MOBILITY ADVISORY COMMITTEE MEETING MINUTES

Thursday, November 14, 2024, 1:00 PM

Project Name: Region 4: US97 Scale House Camera K24075

Project Name: Region 2: OR6 at Aerts Road Roundabout

Figure 10: Proposed Changes for US97 ~Milepost 146.02

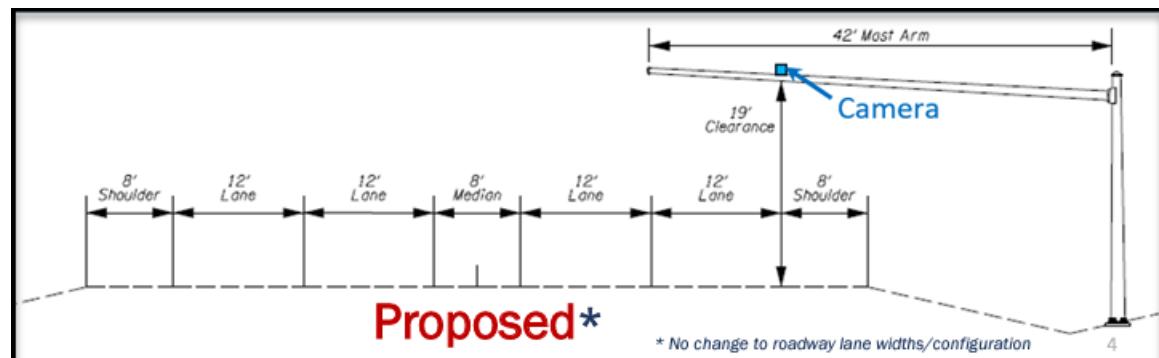
MAC Member Erik Zander (Omega Morgan) asked if the mast arm holding the camera can be driven around by getting into the fast lane of traffic.

Teresa Gibson (Region 4 Mobility Liaison) confirmed that this was the case.

Figure 16: Proposed Roundabout Design Drawing

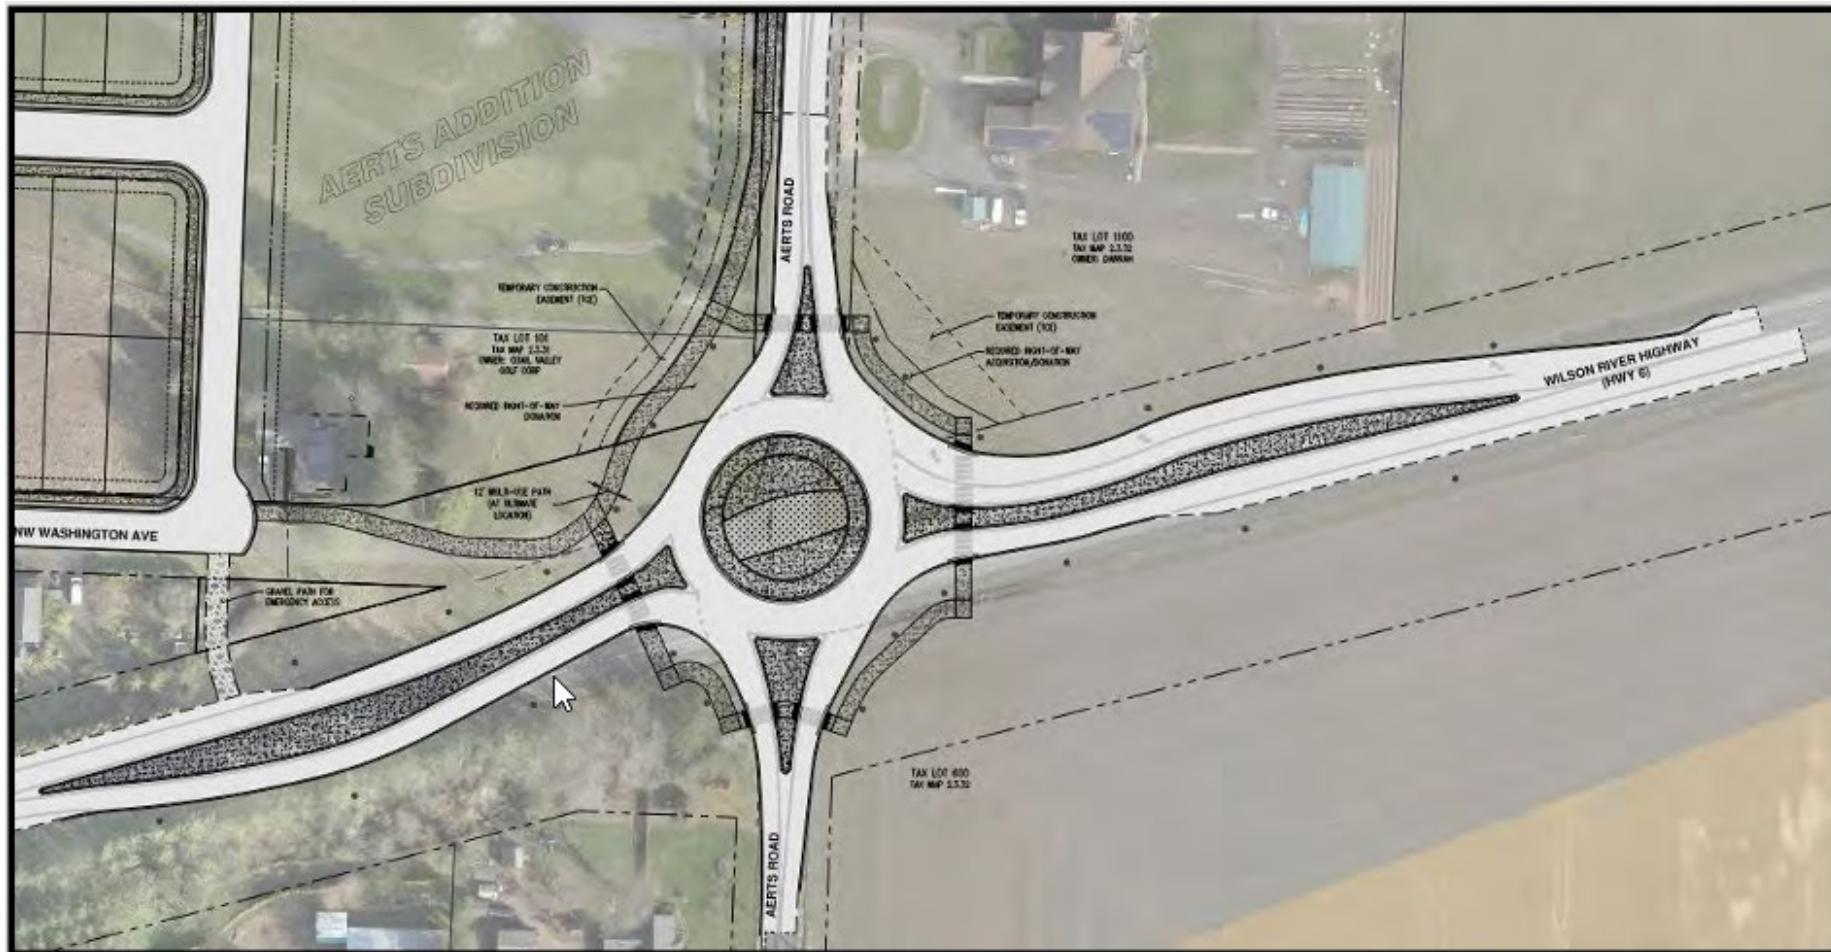
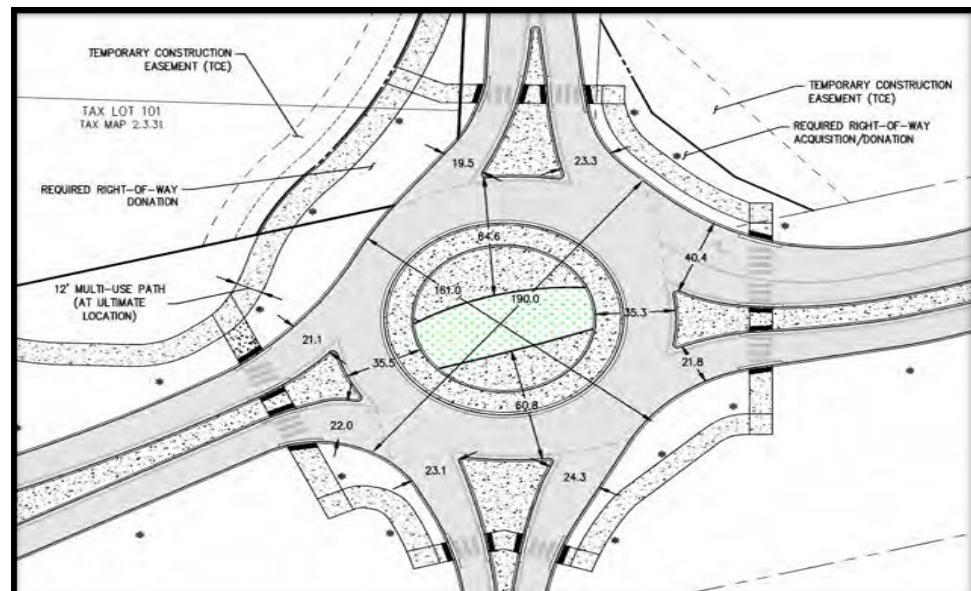
MAC Member Walt Gamble (Associated General Contractors) wanted to second the question that MAC Member Erik Zander had asked earlier: does the roundabout need to be strictly a circular roundabout? He states that there is at least one instance from ODOT that an elongated roundabout helped mitigate truck traffic needing to use the truck apron and other mountable curbs.

Hearing no more questions, Matt Steigleider discussed in depth about the turning movements (imaged above). He notes that the splitter island can be used by the longer loads, as the signs posted on them are far enough away from the roadway as to not get hit. Once the vehicle sizes get larger, signs will need to be removed to get the loads through. He also discussed the heavy haul (114.4-feet) turn movement was added after the last MAC meeting this was presented (shown above). This sized load will need to utilize the two-tiered truck apron to move through the roundabout. He points out that the load is close to clipping the central island, and that the design team will be working to refine the size.

Figure 17: Design Vehicle Turning Movement Diagram (WB-67)

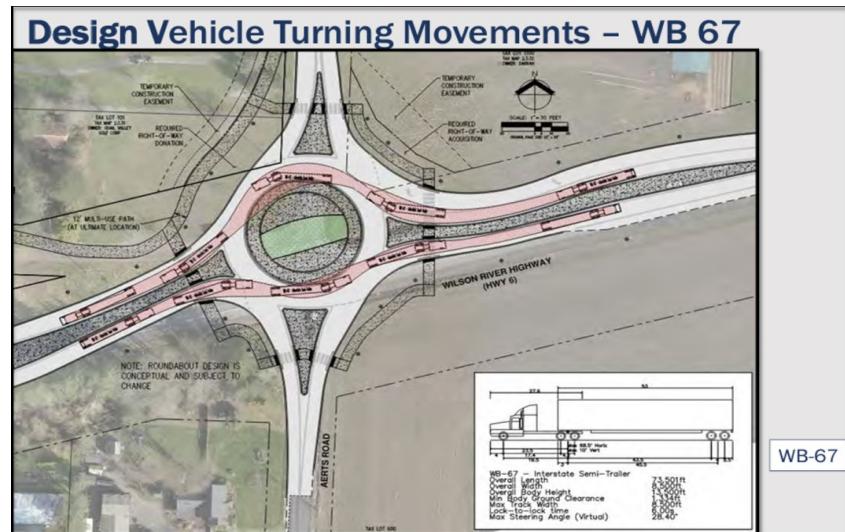
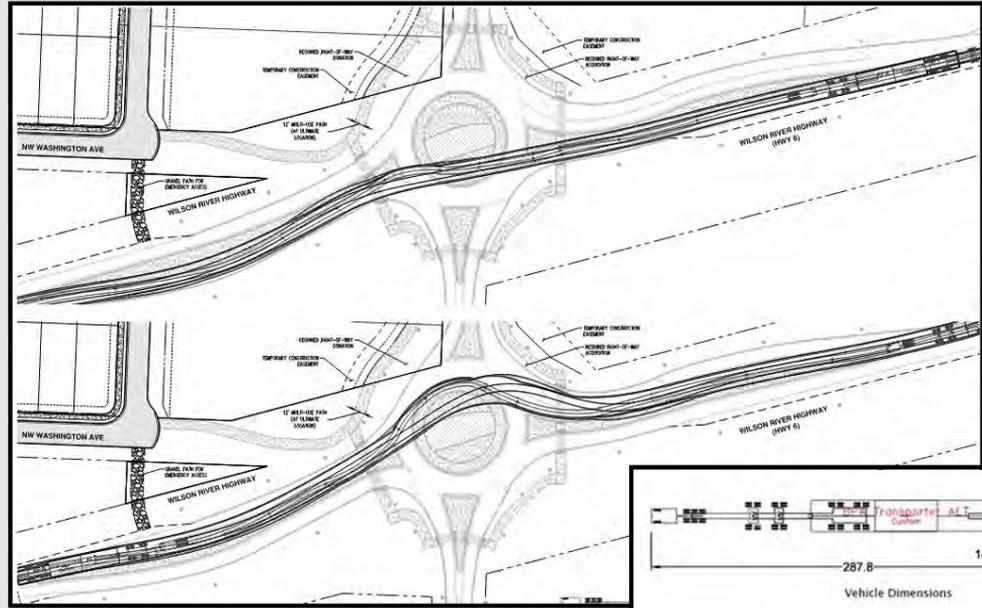
MAC Member Erik Zander (Omega Morgan) wanted clarification on how the WB-67 model was run, as the design looks like it's going the straightest path it can take through the roundabout. He stated that he would likely use as much roadway to the south as possible to avoid using the mountable curb as much as possible.

MAC Member Erik Zander (Omega Morgan) stated that the reason for bringing this up was due to the industries concerns of entering and exiting roundabouts, and not necessarily "Can I fit the load through?". Through research, previous modeling might have been off in part because of what it takes to get a truck in and out from a dead stop, and as more traffic is added, this makes it even harder to do. This in part was the reason he had asked about an elongated roundabout at this location. The concern is also in part due to the potential threat of tip over and tire wear and tear that truck aprons can cause. He finishes by asking if the WB-67 could stay off the curve (truck apron).

Matt Steigleder (AKS) responded by saying that they wanted to show the worst-case scenario as possible when doing these turning movements. They also wanted to make sure that the truck apron was appropriately sized. He added that the project wanted to add a more typical 20-foot width lane to help control traffic speed through the roundabout, and that there is flexibility on how the load can move through the roundabout.
